# PHY quality criterion RS-FEC Frame Error Ratio (RFER) Comment #146 to D1.2

Rubén Pérez-Aranda, KDPOF

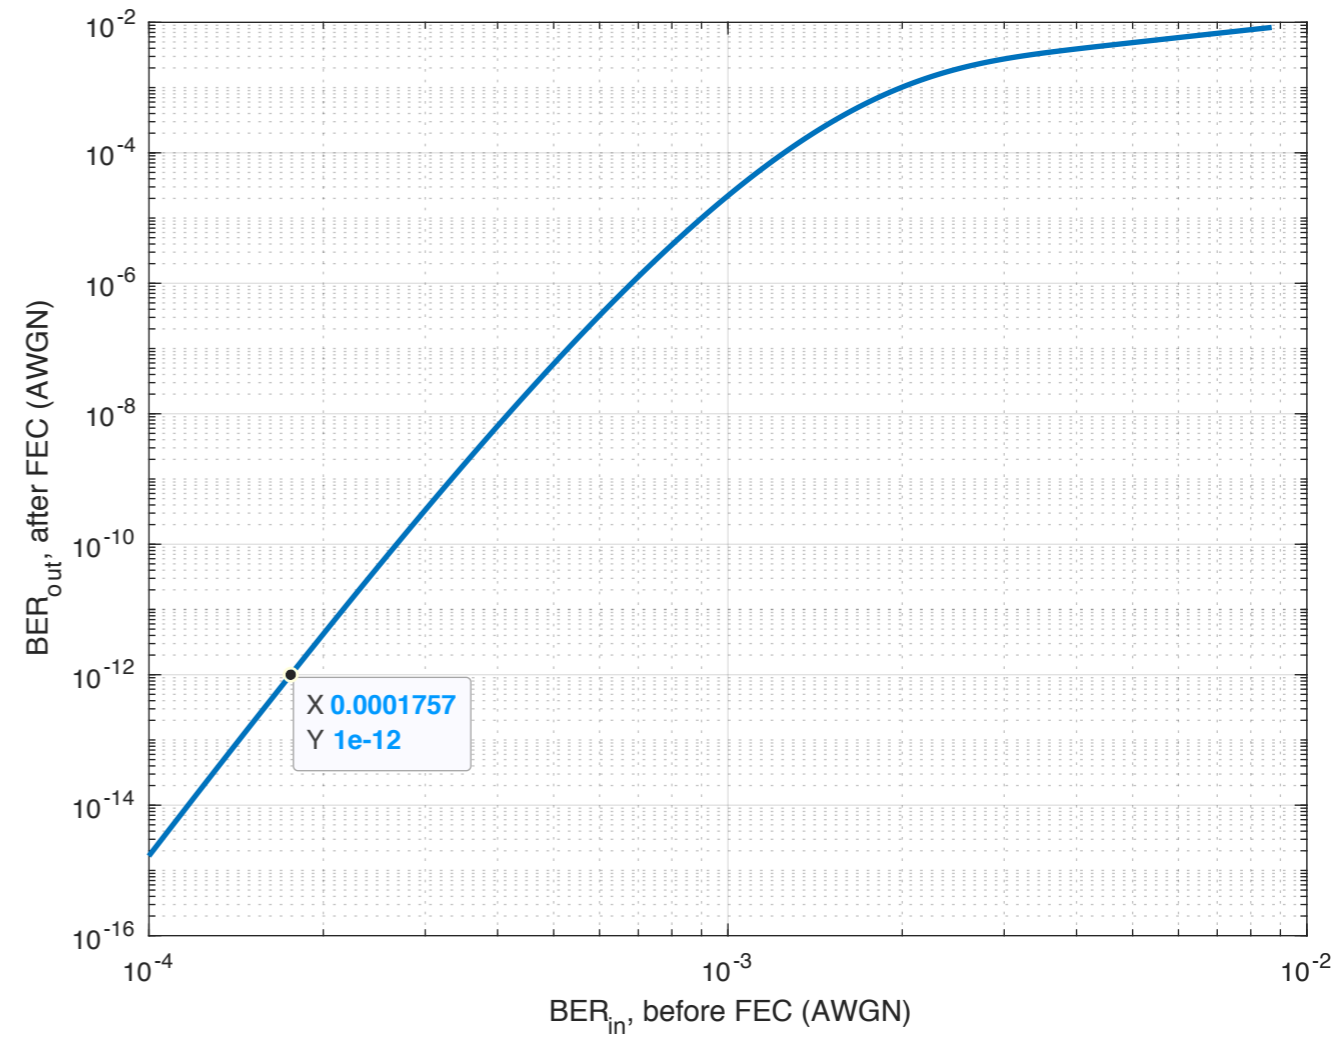
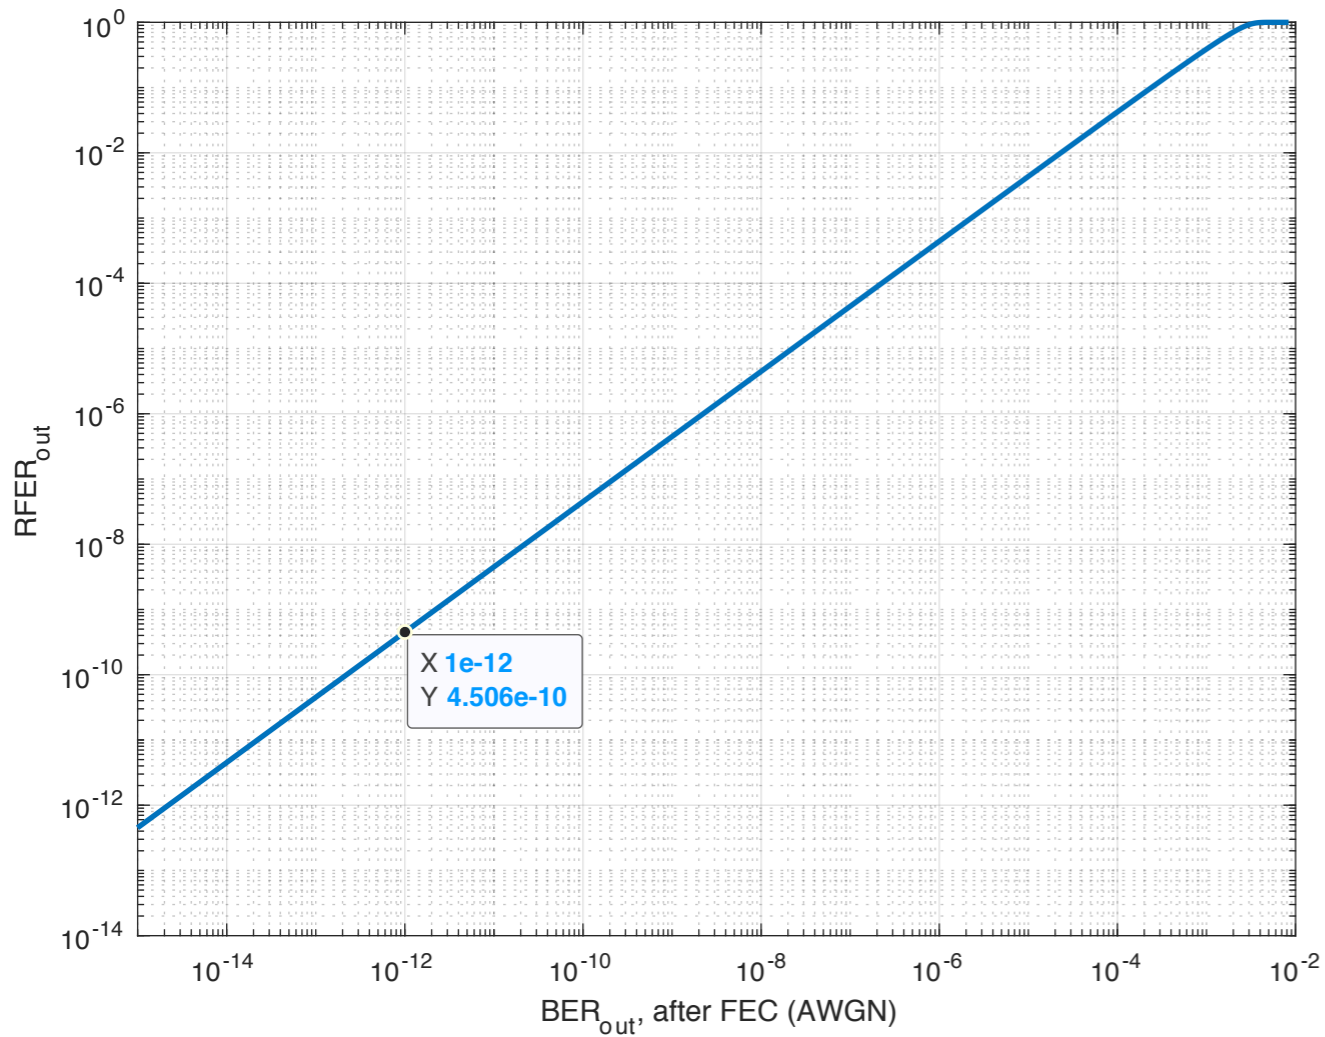
# Error ratio equations

- $SER_{in}$ : RS symbol error ratio at the RS decoder input (before decoding)
- $SER_{out}$ : RS symbol error ratio at the RS decoder output (after decoding)
- $BER_{in}$ : bit error ratio at the RS decoder input (before decoding)
- $BER_{out}$ : bit error ratio at the RS decoder output (after decoding)
- $RFER_{out}$ : RS frame error ratio at the RS decoder output (after decoding)

$$SER_{in} = \sum_{i=1}^m \binom{m}{i} \cdot BER_{in}^i \cdot (1 - BER_{in})^{m-i}$$

$$SER_{out} = \sum_{i=t+1}^n \frac{i}{n} \binom{n}{i} \cdot SER_{in}^i \cdot (1 - SER_{in})^{n-i}$$

$$RFER_{out} = \sum_{i=t+1}^n \binom{n}{i} \cdot SER_{in}^i \cdot (1 - SER_{in})^{n-i}$$

$$BER_{out} = \frac{SER_{out}}{m}$$

# RFER limit

$$\text{RFER} < 4.5 \times 10^{-10}$$
